THM 700-R4 "UPDATE HANDBOOK"

AUTOMATIC TRANSMISSION SERVICE GROUP

Figure 12

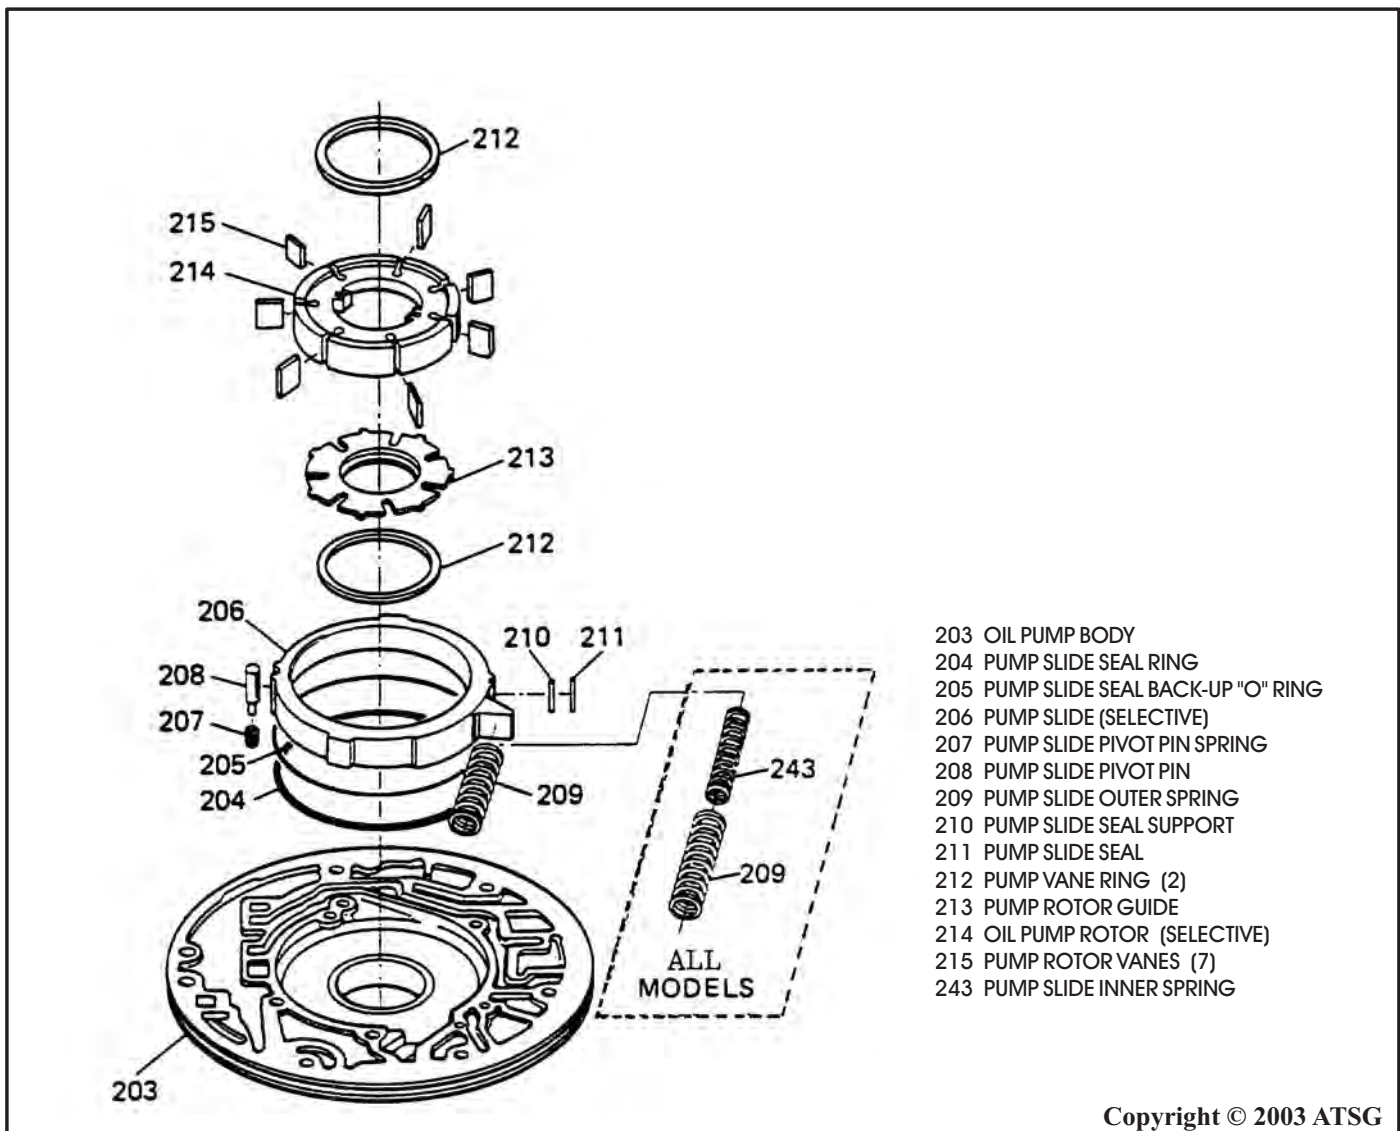
CHANGE: Beginning on March 4, 1985, all THM 700-R4 transmissions were built with a new oil pump assembly that uses inner and outer slide springs, as shown in Figure 12.

- (1) OIL PUMP ASSEMBLY - Now uses an inner slide spring and an outer slide spring, as shown in Figure 12.

Inner Pump Slide Spring	8639562
Outer Pump Slide Spring	8639563

Figure 15

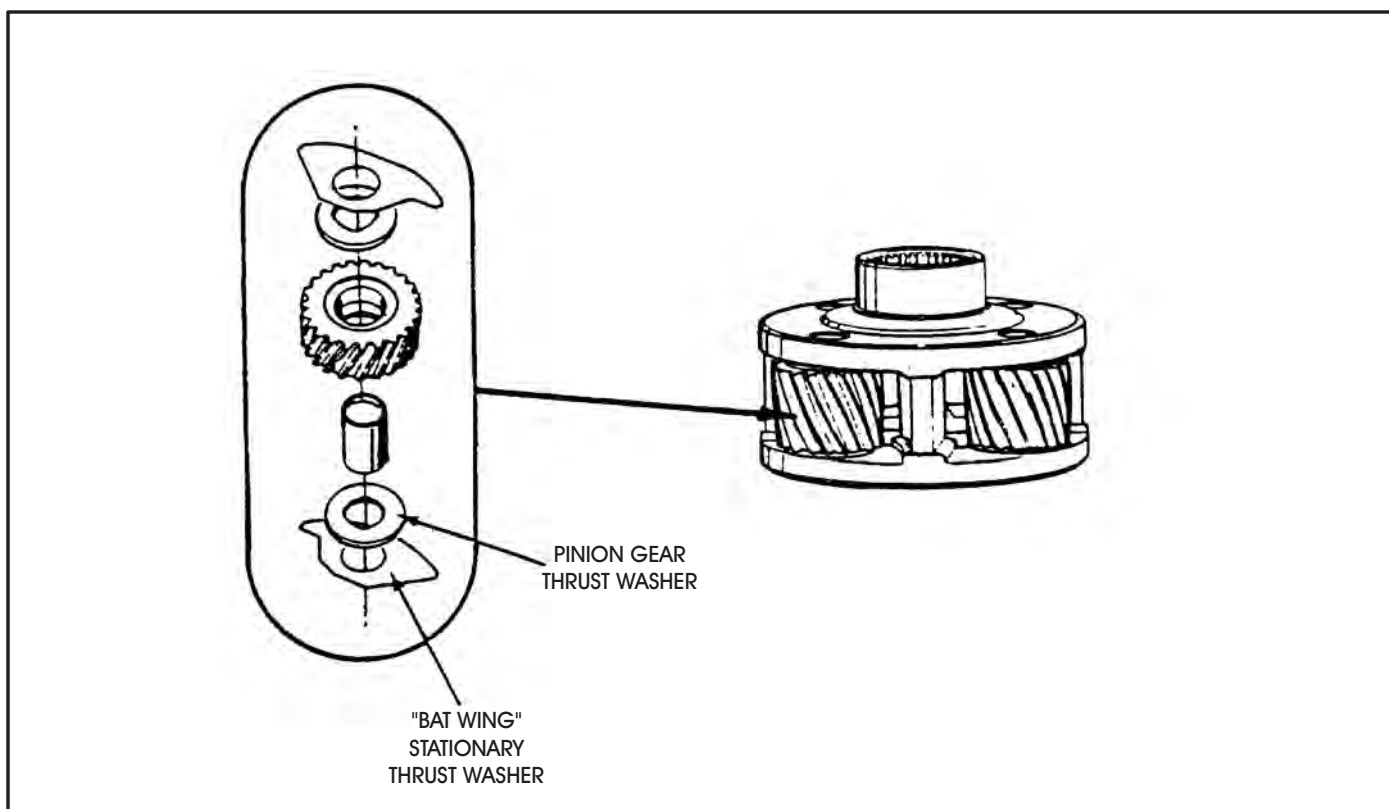
CHANGE: Beginning at the start of production for 1985 models, all THM 700-R4 transmissions were built with a new design Input Carrier that has added "Bat Wing" thrust washers on each side of the pinion gears, as shown in Figure 15.

- (1) INPUT CARRIER - Were built with stationary "Bat Wing" thrust washers in place of the previous bronze thrust washers, as shown in Figure 15.

Input Carrier Assembly (2nd Design) 8654329

Figure 18

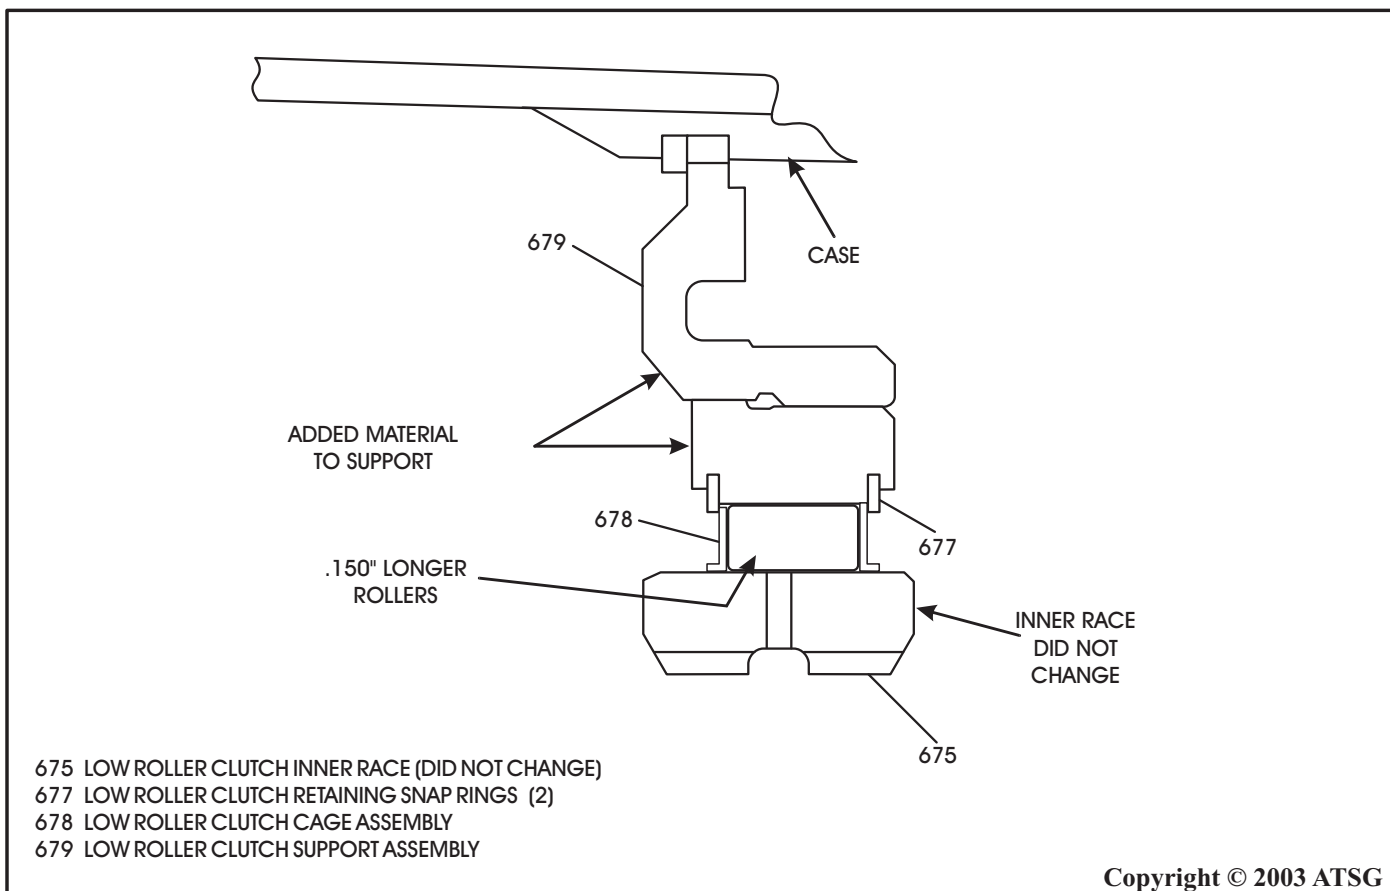
CHANGE: Beginning on June 19, (Julian Date 170) 1986, all THM 700-R4 transmissions were built with a new design Low Roller Clutch assembly with .150" longer rollers which also required a new design cage, as shown in Figure 18.

- (1) **LOW ROLLER CLUTCH ASSEMBLY** - The rollers increased in length by .150", which would also change the cage, as shown in Figure 18.
- (2) **LOW ROLLER CLUTCH SUPPORT ASSEMBLY** - Increased length of the support and cam assembly, to accommodate the new design longer low roller clutch, as shown in Figure 18.

General Motors has a service kit available, to update to the new design low roller clutch under part number 8663094.

Figure 19

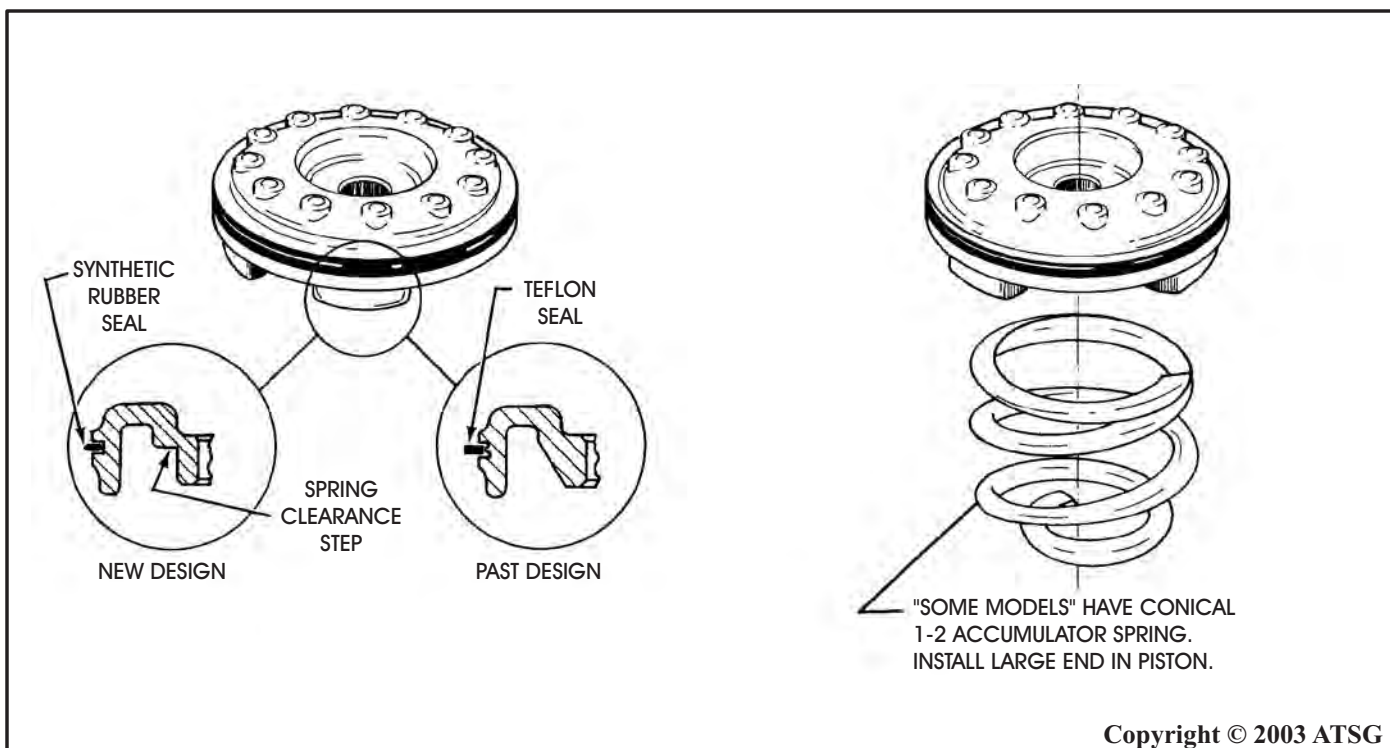
CHANGE: Beginning on June 18, (Julian Date 169) 1986, all THM 700-R4 transmissions were built with a new design 1-2, 3-4, and forward clutch accumulator pistons that use a soft synthetic rubber seal instead of the previous teflon material. There is also a new clearance step for the spring, as shown in Figure 19.

- (1) ACCUMULATOR PISTON SEALS - They are now manufactured from a soft synthetic rubber material, instead of the previous Teflon material, as shown in Figure 19.
- (2) ACCUMULATOR PISTONS - The 1-2, 3-4, and forward accumulator pistons now have a revised shape seal groove to accommodate the new design accumulator seals and a different machining process for the accumulator springs, as shown in Figure 19.
- (3) 1-2 ACCUMULATOR SPRING - "Some Models" now require a conical shaped accumulator spring, to eliminate coil bind, and large end of the spring goes toward the piston, as shown in Figure 19.

The new design rubber accumulator piston seals *cannot* be used on the previous design piston that uses the Teflon seal.

The new design accumulator pistons with rubber seals can be used to back service all previous models of the THM 700-R4 transmissions.

Figure 20

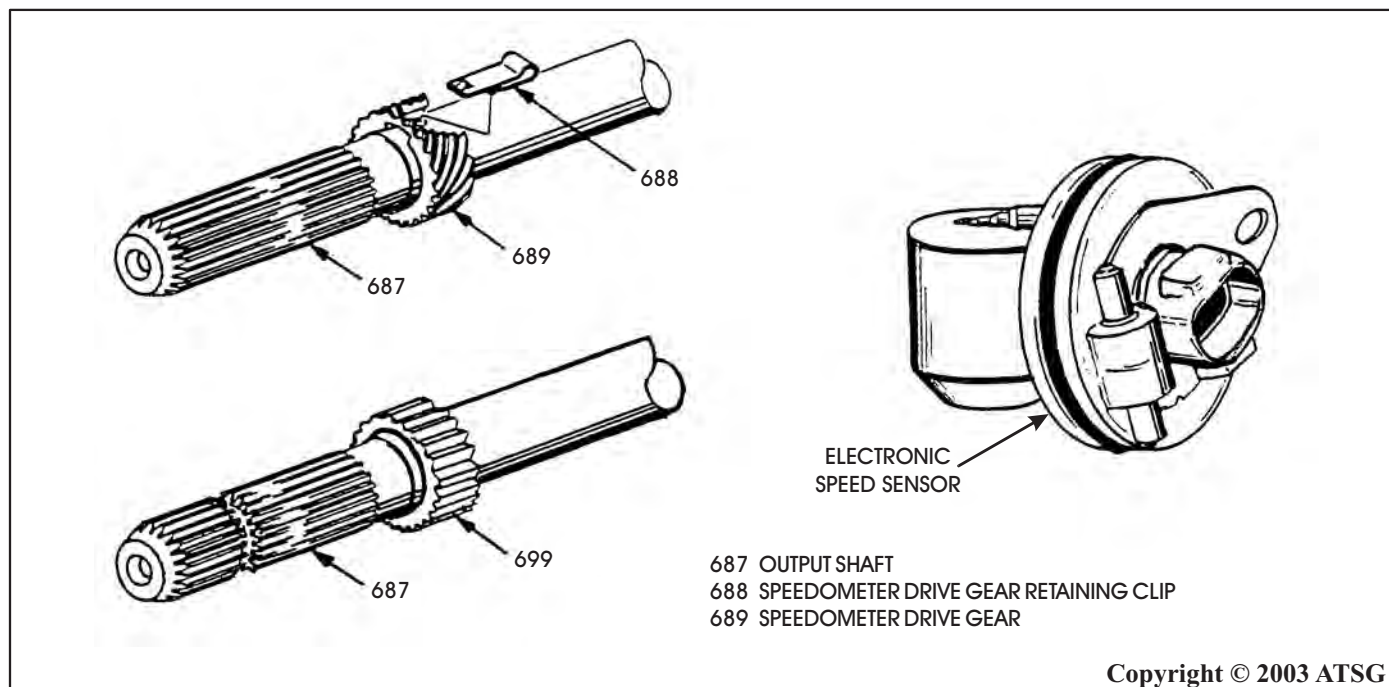
CHANGE: Beginning on July 17, 1986 for *some* 1987 models, Hydra-Matic introduced an electronic speed sensor, which is used by the ECM to provide anti-skid braking. The speed sensor and speed sensor rotor replace the speedometer driven gear adaptor and the speedometer drive gear, as shown in Figure 20. Used in 1987 model "C" Trucks with 4.3L, 5.0L, 5.7L, (Gas) and 6.2L Diesel engines.

- (1) **SPEED SENSOR** - The added Speed Sensor replaces the speedometer driven gear adaptor and the speedometer drive gear, as shown in Figure 20.
- (2) **OUTPUT SHAFT** - Has an added groove to remove and install the added speed sensor rotor, using a special puller (See Figure 20).
- (3) **TRANSMISSION CASE** - Orifice cup plug added in the governor bore which now provides lubrication to the extension housing bushing, when the speed sensor rotor is used. Refer to Figure 21. This lube was normally provided by the spinning speedometer driven gear teeth tossing oil to the bushing. When the speedo gear is replaced with a speed sensor rotor, the forced lube from the orifice cup plug is required (See Figure 21).

Speed Sensor Rotor (All Models)	8663090
Speed Sensor	8654750

Figure 22

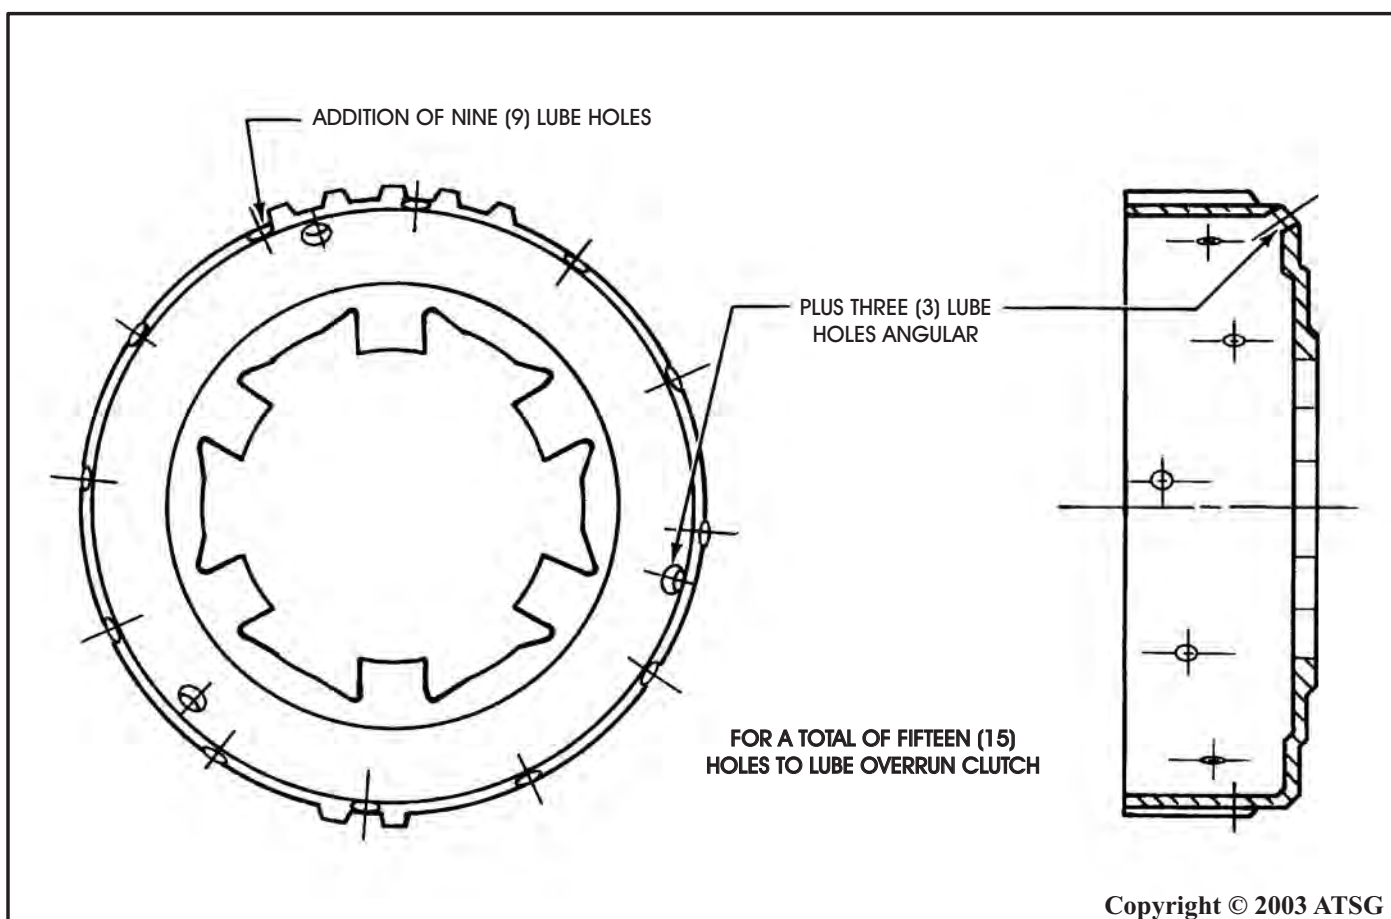
CHANGE: Beginning on July 17, (Julian Date 198) 1986, all 1987 THM 700-R4 transmissions were built with a new overrun clutch hub with more lube holes drilled, as shown in Figure 22.

- (1) **OVERRUN CLUTCH HUB** - Now has twelve lube holes drilled in the circumference of the hub instead of the previous three, plus three angular holes for a total of 15 holes, as shown in Figure 22.

The new design Overrun Clutch Hub will come as part of the new design 28 element forward sprag assembly, shown beginning on Page 24, and the new sprag assembly is available under OEM part number 8657928.

Figure 23

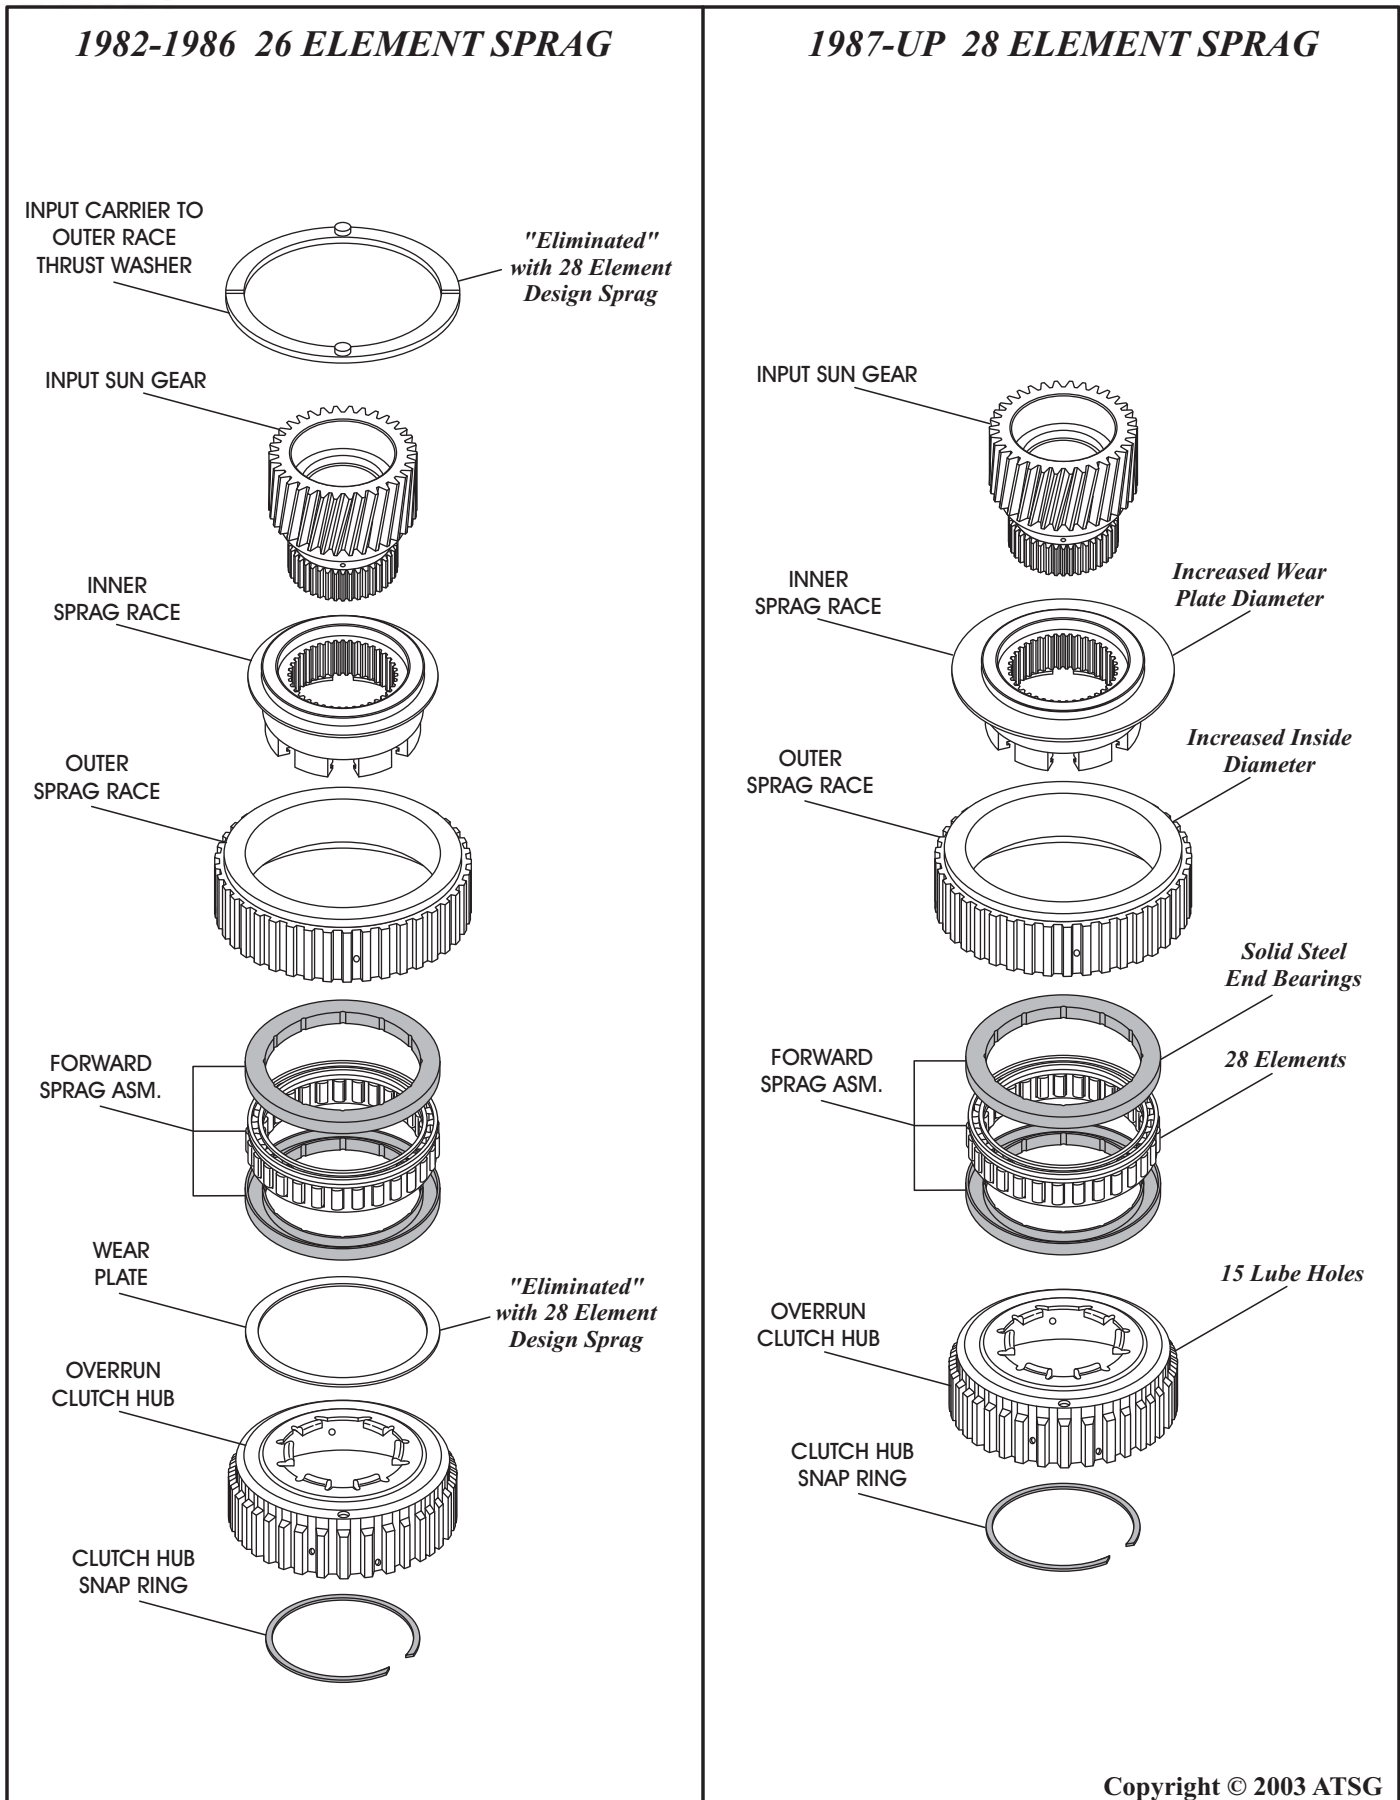
CHANGE: Beginning on July 17, (Julian Date 198) 1986, all 1987 THM 700-R4 transmissions were built with a new Forward Sprag Assembly with increased sprag elements (See Figure 23).

- (1) FORWARD SPRAG ASSEMBLY - Increased diameter and addition of two sprag elements for a total of 28, instead of the previous 26 (See Figure 23).
- (2) FORWARD SPRAG OUTER RACE - Has larger inside diameter to accommodate the 28 element sprag assembly (See Figure 23).

- (3) FORWARD SPRAG INNER RACE - Has larger outside diameter to accommodate the 28 element sprag assembly, and an increase in the diameter of the wear plate that is pressed onto the inner race (See Figure 23).

- (4) FORWARD SPRAG END BEARINGS - Now has solid steel end bearings instead of the previous stamped steel end bearings (See Figure 23).
- (5) FORWARD SPRAG WEAR PLATE - Eliminated in the 28 element version to make room for the new design solid steel end bearings (See Figure 23).

- (6) INPUT CARRIER THRUST WASHER - Eliminated in the 28 element version as the increased diameter of the wear plate now supports the outer race (See Figure 23).

The individual components listed above **are not** interchangeable with previous design levels. The new design 28 element Forward Sprag Assembly is highly recommended, and will back service all previous models by replacing the "**Entire Assembly**" as a service package.

The Input Carrier to Outer Sprag Race thrust washer and Wear Plate **are not** required with the new design 28 element Forward Sprag Assembly. Use of the Input Carrier thrust washer with the new design sprag will create a mis-build, as correct front end play cannot be obtained (See Figure 23).

The new design 28 element Forward Sprag Assembly includes the updated Overrun Clutch Hub shown in Figure 22, and is available under OEM part number 8657928.
